E8361C-05

S E R V I C E N O T E

E8361C PNA Microwave Network Analyzers

A new touchscreen display inverter shield is available to improve PNA noise floor performance.

Figure 3

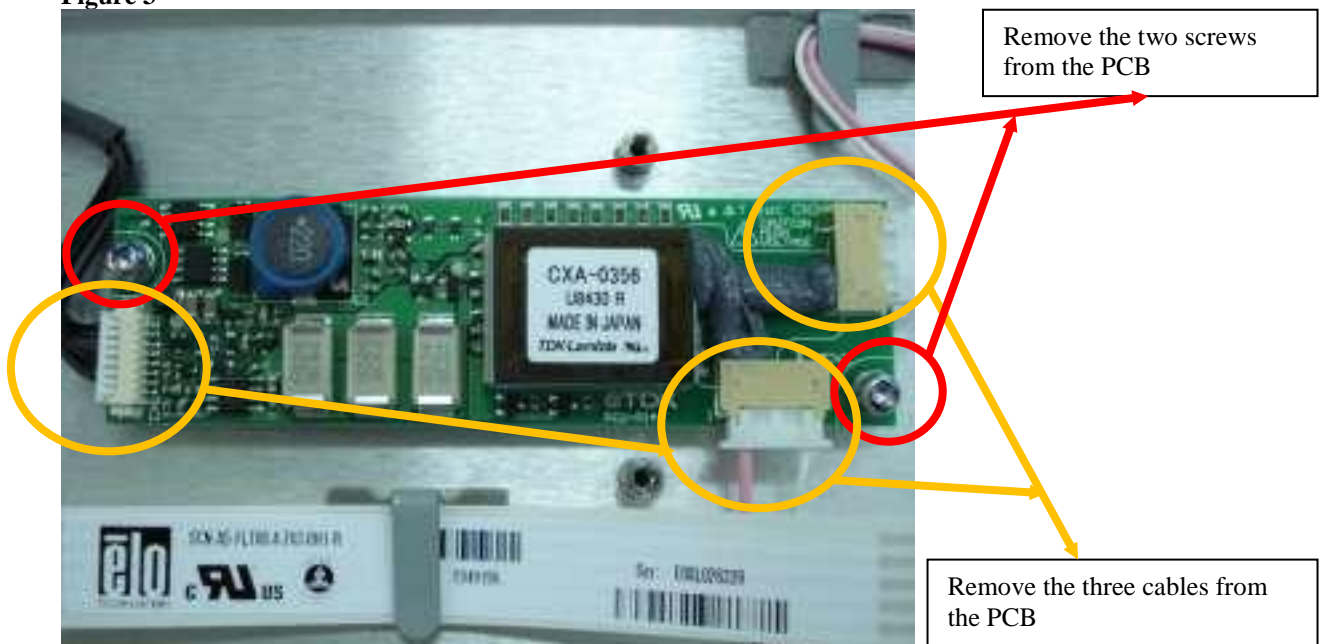
10. Remove the two screws from the PCB shown in Figure 3, using a T-10 wrench.
Disconnect the three cables connected to the PCB.
